K95KNGP500 Class II Permissive Change Request – Circuit Change Description

Applicant: RELM Wireless Corporation
FCC ID: K95KNGP500

Figure 2 – Transmitter with Changes to Support Emissions Designator 8K10F1W

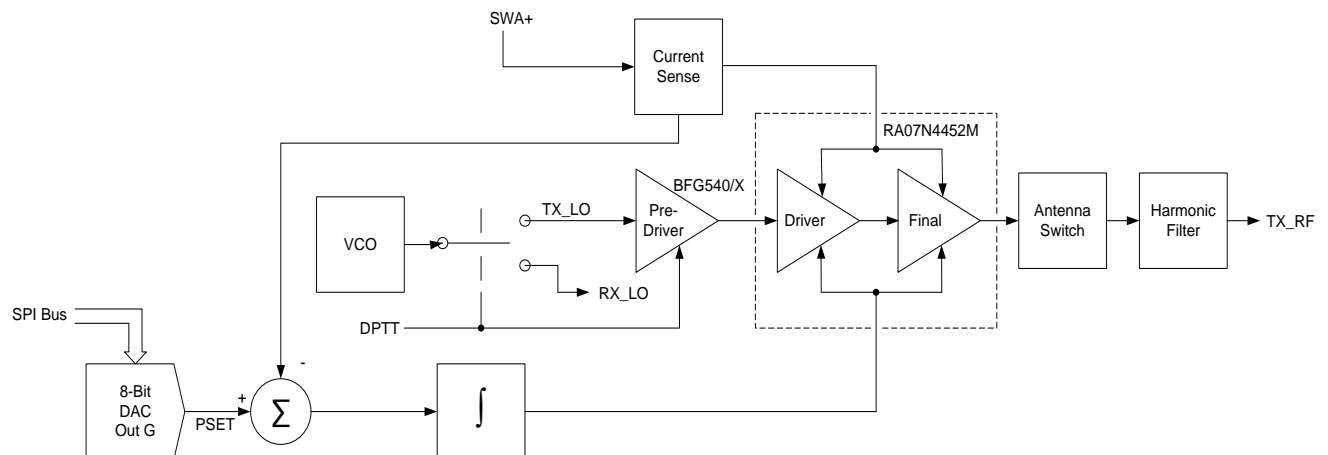
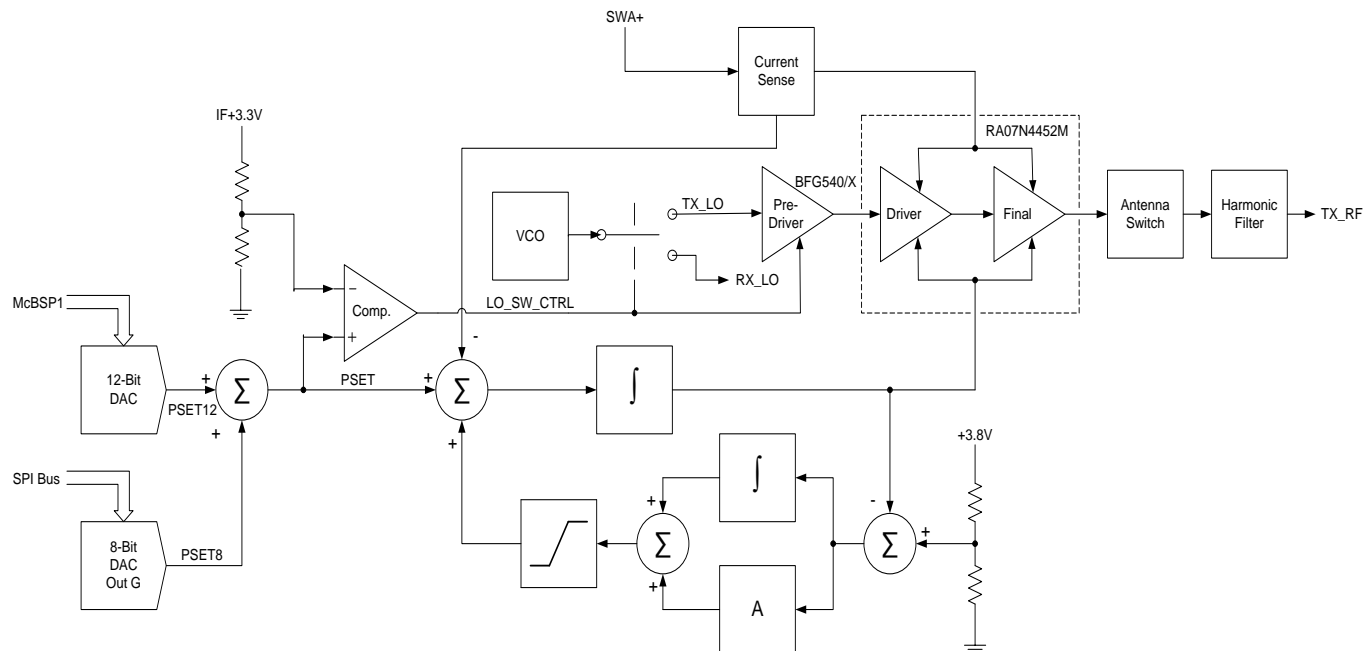
The following circuit change has been made to FCC ID K95KNGP500 under the Class II Permissive Change guideline for this FCC ID to have P25 Phase II Operation incorporated; thus, requiring Emissions Designator 8K10F1W to be added.

Some changes to the transmitter power control circuitry are required in order to support the more accurate power ramping required for P25 Phase II operation (emissions designator 8K10F1W). These changes consist of: the addition of a 12-bit DAC to set power, the addition of a comparator to control the existing RX/TX LO switch, and the addition of a secondary control loop to maintain a resistor divider determined offset on the driver and final gate voltages during the off slot. Figure 1 below shows a block diagram of the transmitter as it was when the K95KNGP500 type acceptance was granted and Figure 2 shows a block diagram of the transmitter with the changes required to support emissions designator 8K10F1W. No changes have been made to the synthesizer, VCO, pre-driver stage, PA module, antenna switch, or harmonic filter. None of the changes will affect maximum output power.
